POTENTIAL PROBLEMS FROM SHIPMENT OF HIGH-CURIE CONTENT  
CONTACT-HANDLED TRANSURANIC (CH-TRU) WASTE TO WIPP

Environmental Evaluation Group  
7007 Wyoming Boulevard NE, Suite F-2  
Albuquerque, New Mexico 87109

August 1983

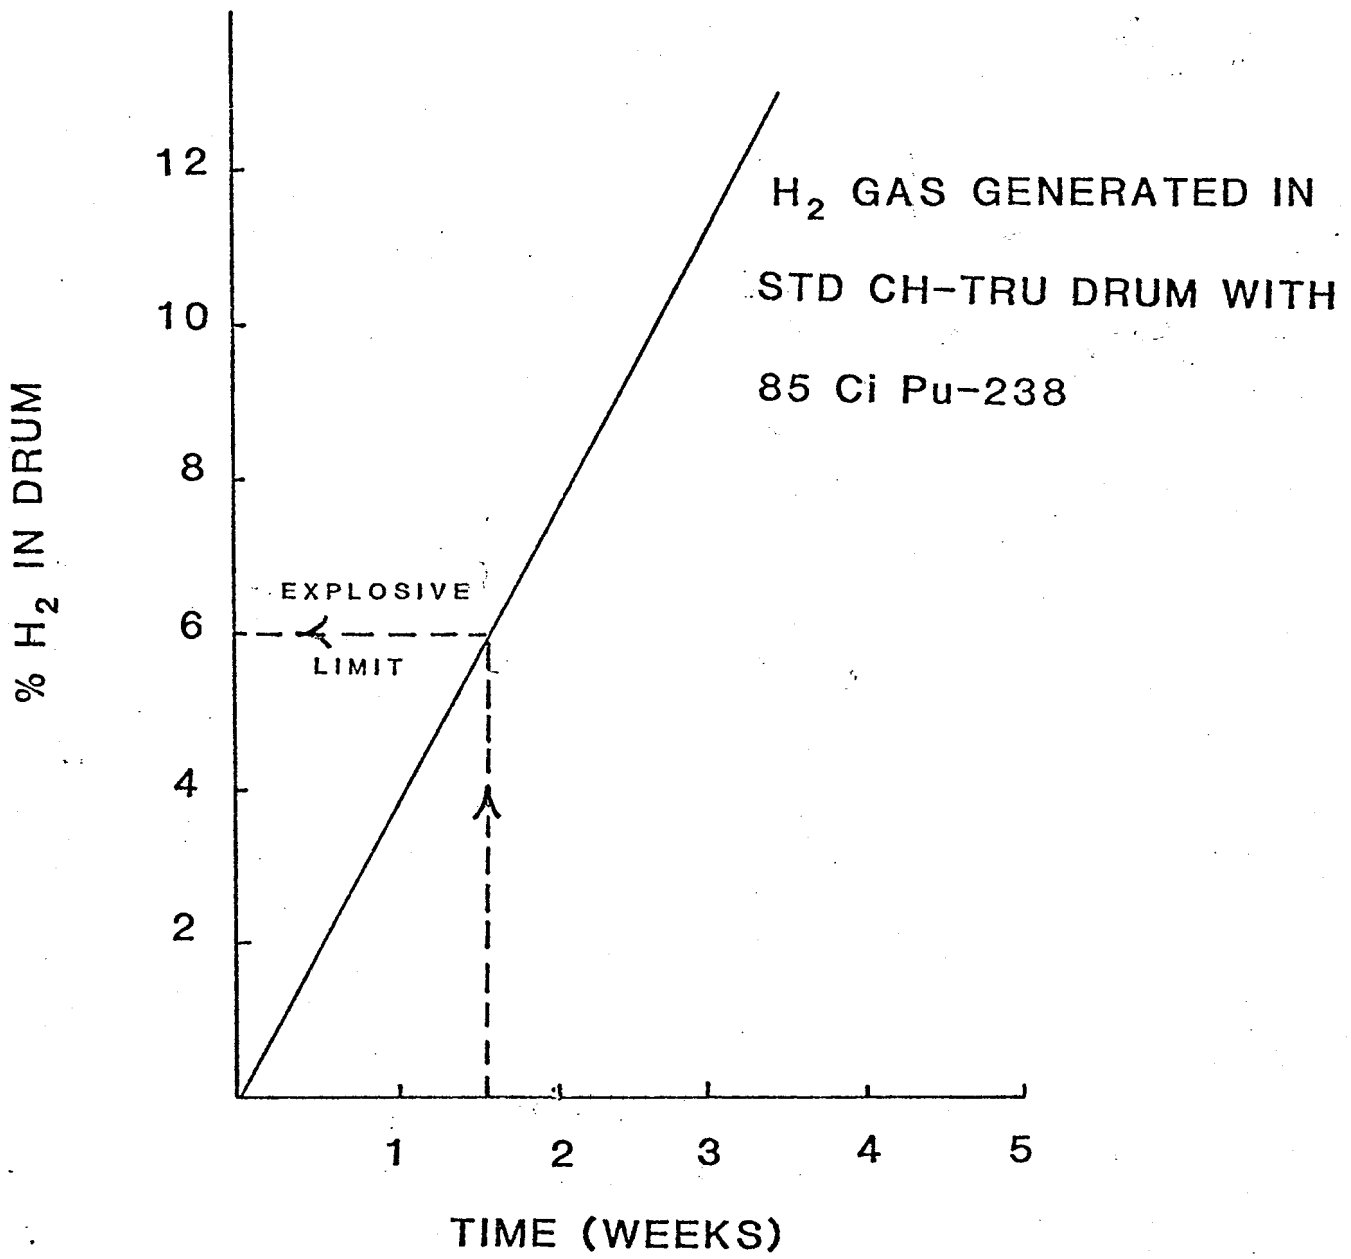
As the following graph shows, a concentration of 6%  $\text{H}_2$  could be realized within two weeks if there is no leakage from the drum seals. Data from SRP and LANL indicate that leakage would be expected to occur. According to Zerwekh (Ref. 12), mixtures of 6% or more are explosive. The following calculation indicates the extent. If all 36 drums in a TRUPACT truck shipment had 6%  $\text{H}_2$ , it would be equivalent to approximately 0.7 pounds of trinitroglycerol. Blasting operations of rock use approximately one pound of this explosive per cubic yard of rock.
